ADDENDUM NUMBER 1

MARCIA COGGS HUMAN SERVICES CENTER HVAC RENOVATIONS RE-BID Site #340, Bldg. #5600 1220 West Vliet Street Milwaukee, WI

Project Number: S032-09434

Date of Addendum: March 26, 2012

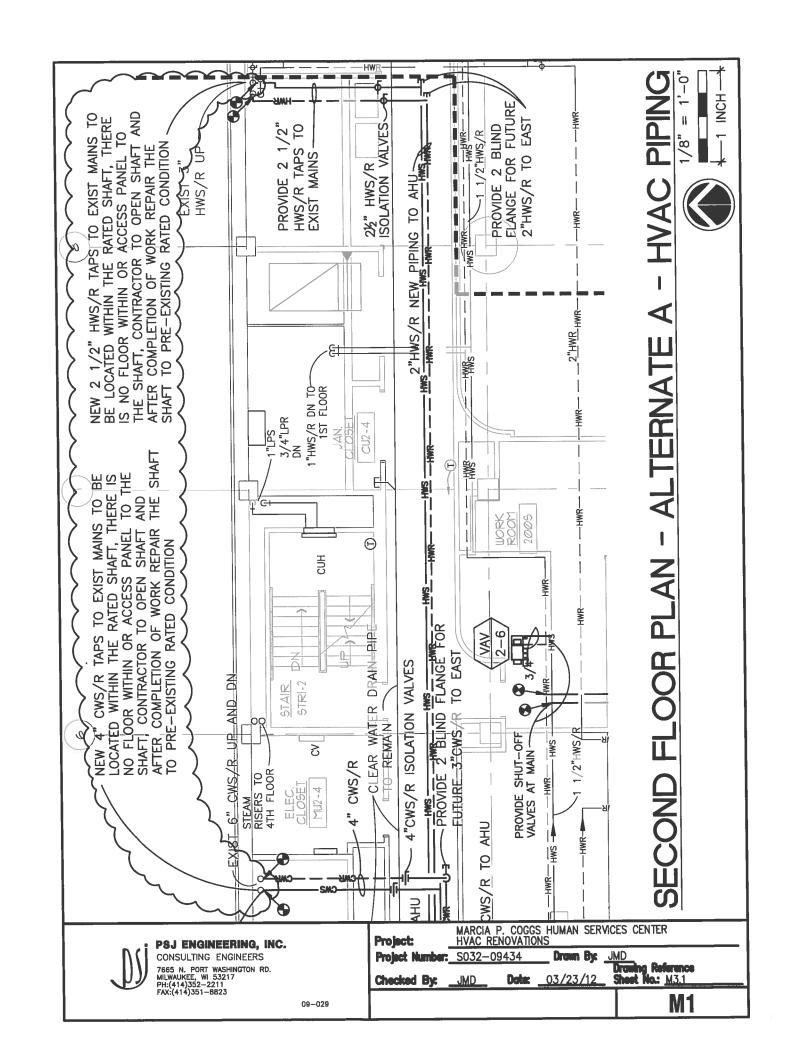
- a. Remove all references to phasing of the work for this project. The owner will not relocate occupants and shall occupy the entire floor for the Base Bid and Alternate A; therefore, no phasing of work is required.
- b. See the attached sketch M1 for additional information on the HWS/R and CWS/R piping tie-in points for Alternate A.
